Docket Item # 9  
BAR CASE # 2015-0269

BAR Meeting  
October 21, 2015

**ISSUE:** New Construction: Building 3

**LOCATION:** 2 Duke Street

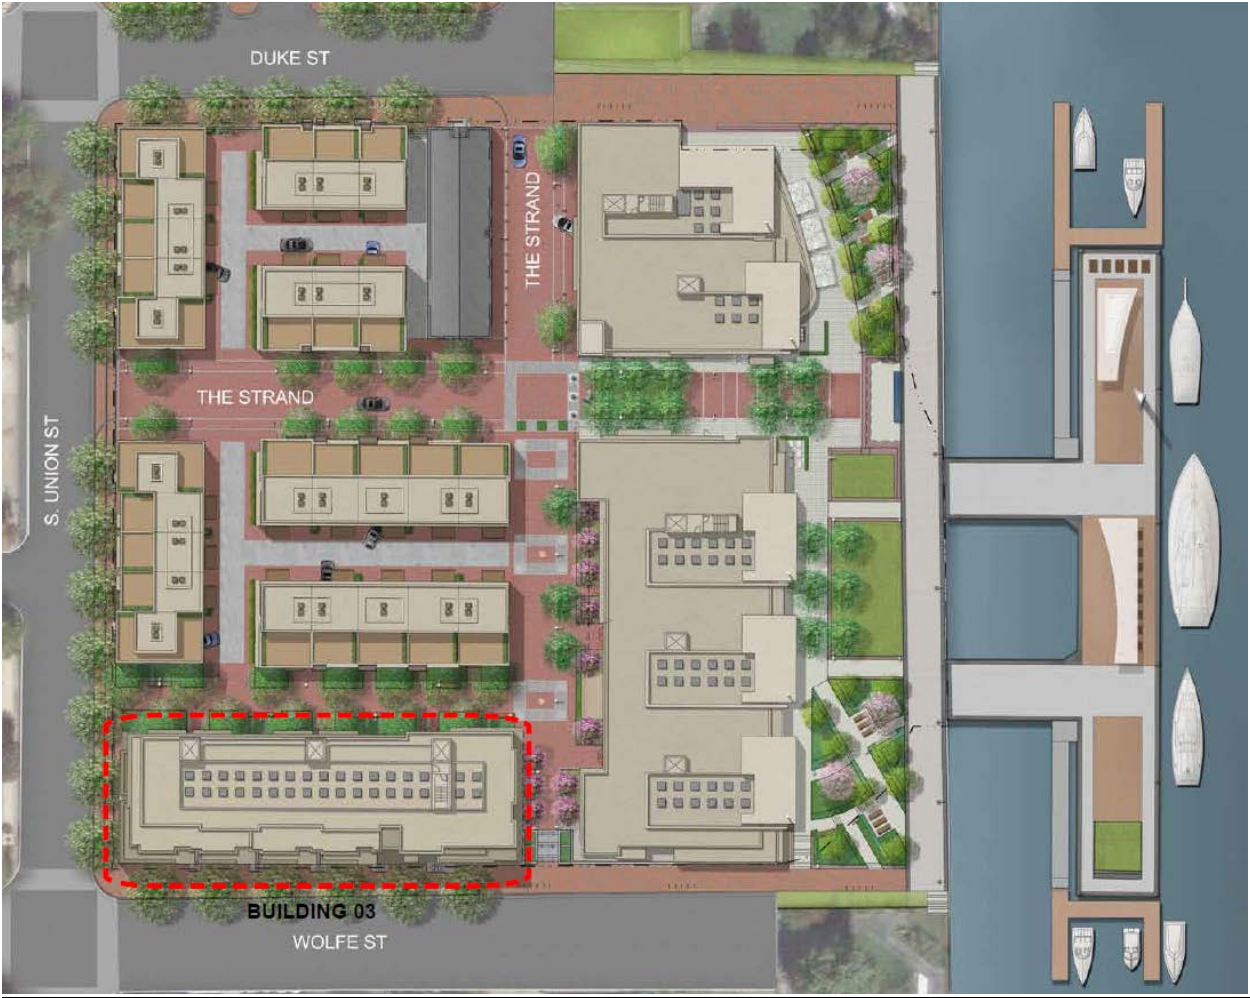
Danny Smith, 401 South Lee Street, stated that this had been an amazing process and that much progress had been made. However, he felt the Wolfe St. façade was still a bit harsh and was concerned about the view of rooftop mechanical equipment from higher elevations.

Joan Huffer, 10 Wolfe Street, asked for additional setbacks, with more differentiation between bays and within the hyphen recesses. She noted that much of this had already been addressed by the applicant and encouraged the process to keep moving forward. She stated that it was a

Hank Savich, 128 Waterford Place, repeated that the more shallow setbacks on the fourth and fifth floors of the Union Street elevation of Building #3 were not fairly proportional to the deeper setbacks on the wider Wolfe Street.

VIEW FROM S. UNION STREET LOOKING NORTH

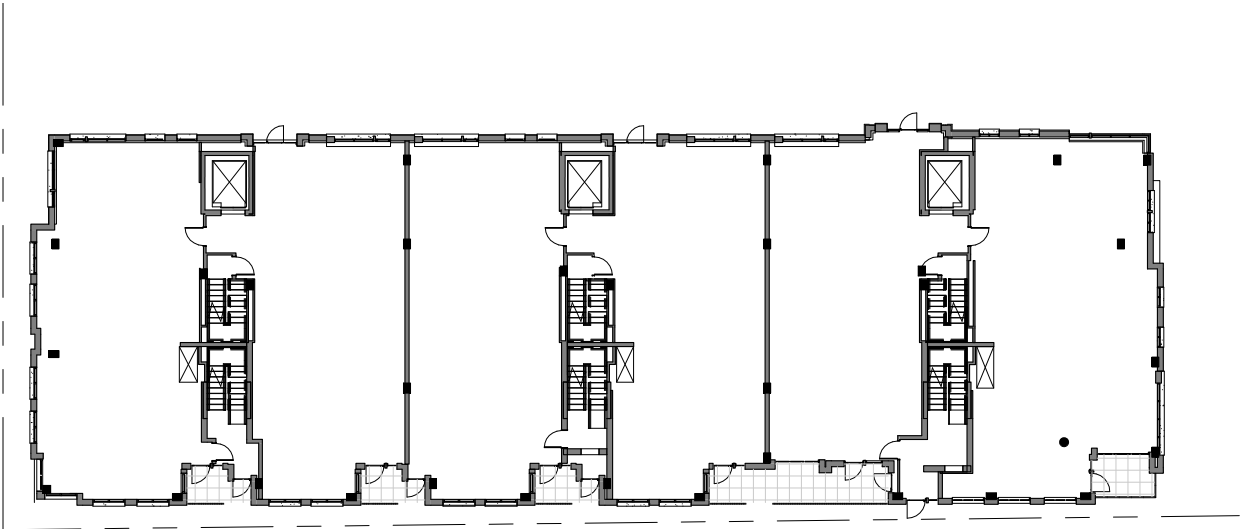
Staff believes that a lighter colored corner has a lot of urban design merit, particularly as one looks north on South Union Street, but may fragment the overall composition of Building 3 too much. *Staff asks for the BAR to provide guidance as to whether a different color brick is appropriate at the southwest corner of Building 3 and, if so, whether the brick should be a light buff color or a darker red brick, with final details to be worked out by staff through the permitting process.*

1. The brick at the corner “townhouse” element on the southwest corner of Building 3 should be revised to be either a distinct red brick clearly differentiated from the brick on Building 3A and the Union Street townhouses OR a lighter, buff brick color.

OVERALL ELEVATIONS

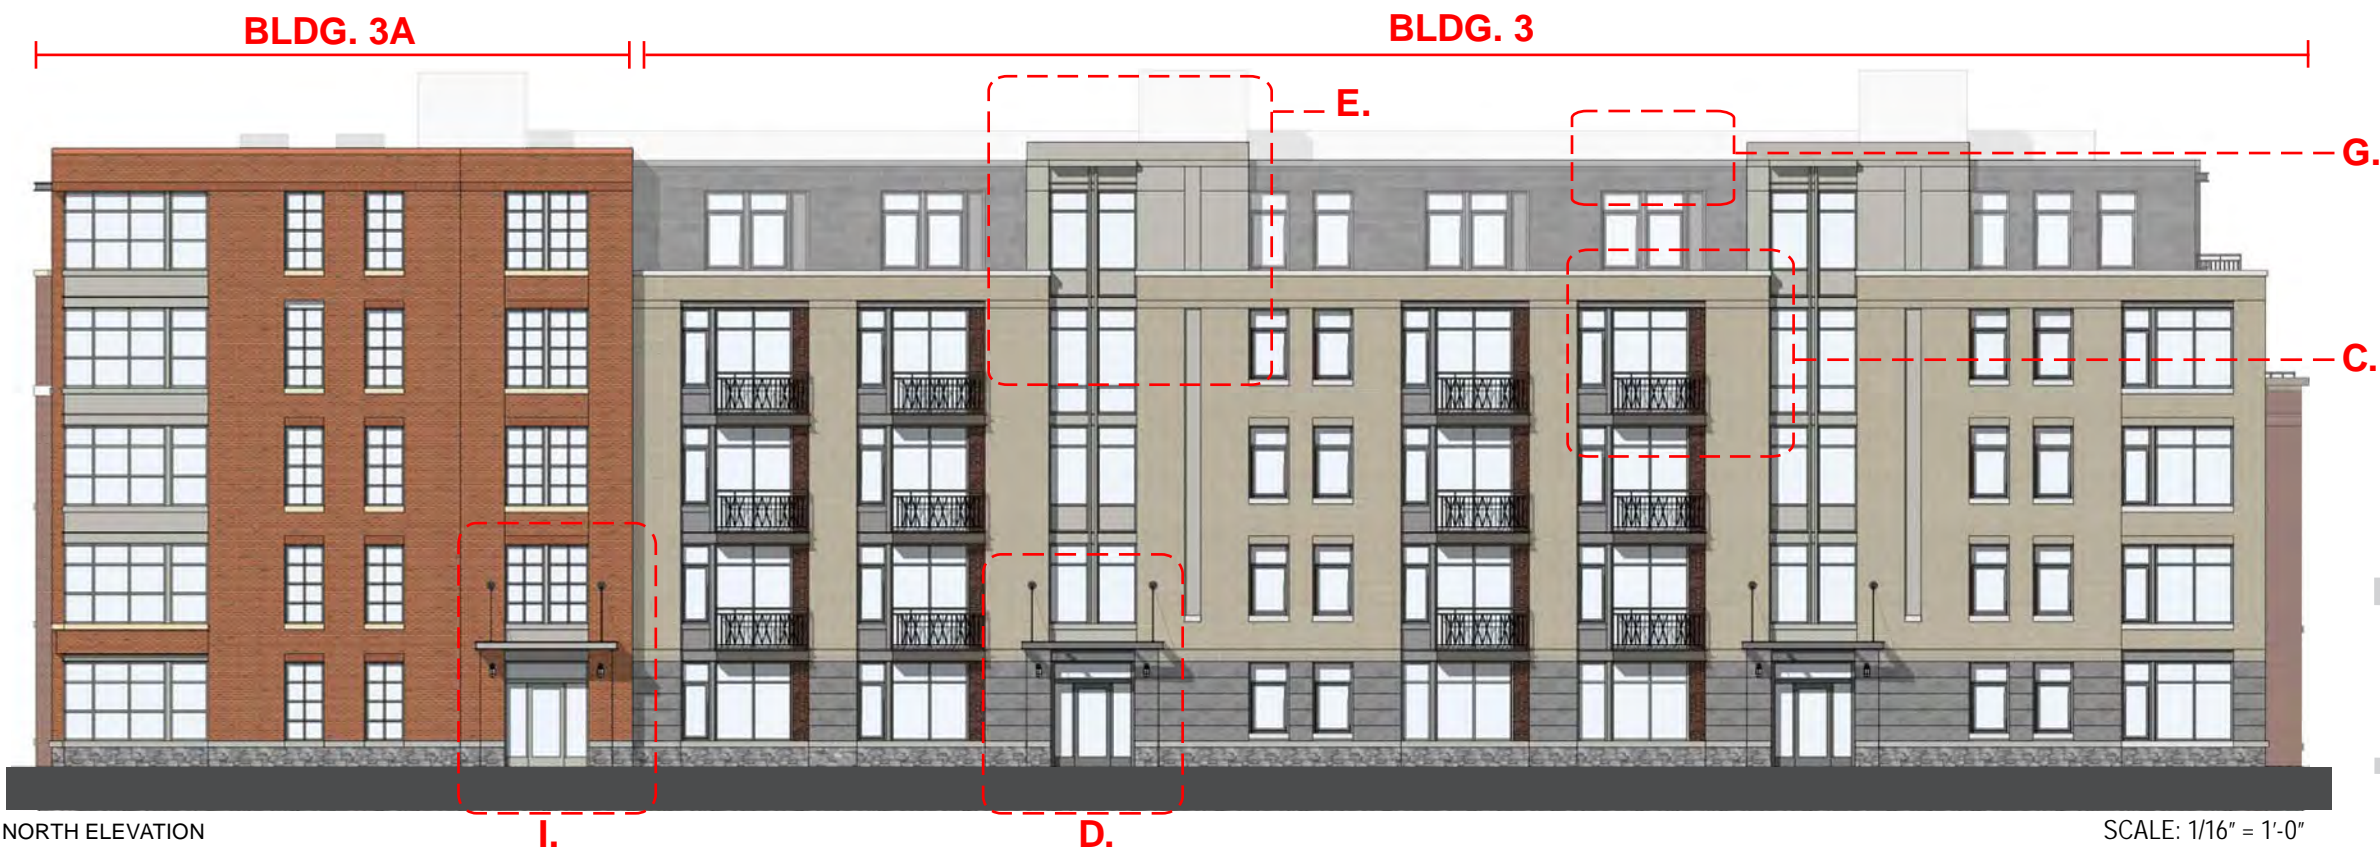
The applicant has refined the north elevation entrances by removing the rough field stone at the surround and leaving it at the base. The entry surround features dressed stone pilasters that relate to the first floor

While a City Council member once famously said that “You can’t have too much red brick,” and the applicant has consciously chosen to present a traditional red brick face to Old Town, the exclusive use of red brick on South Union Street and along Wolfe Street could potentially create the visual effect of a red brick wall surrounding the project. One BAR member suggested studying a lighter brick color at the southwest corner of Building 3 to visually interrupt the red perimeter street wall. The corner “townhouse” element could be the buff brick used on the north elevation of Building 3, or it could be red brick that is clearly distinct and distinguished from the red brick used at 3A and the red brick of the South Union Street townhouses. If the choice of a differentiated red brick is pursued, the brick color change should be readily apparent and not subtle.

1. Work with staff to relieve the monochromatic red brick at the southwest corner of Building #3, using either a clearly differentiated brick color or metal panels.
2. Make all of Building #3A a single red brick color, to create a distinctly different appearance from Building #3, while retaining the layered brick effect and an accent brick color at the windows on the east side.
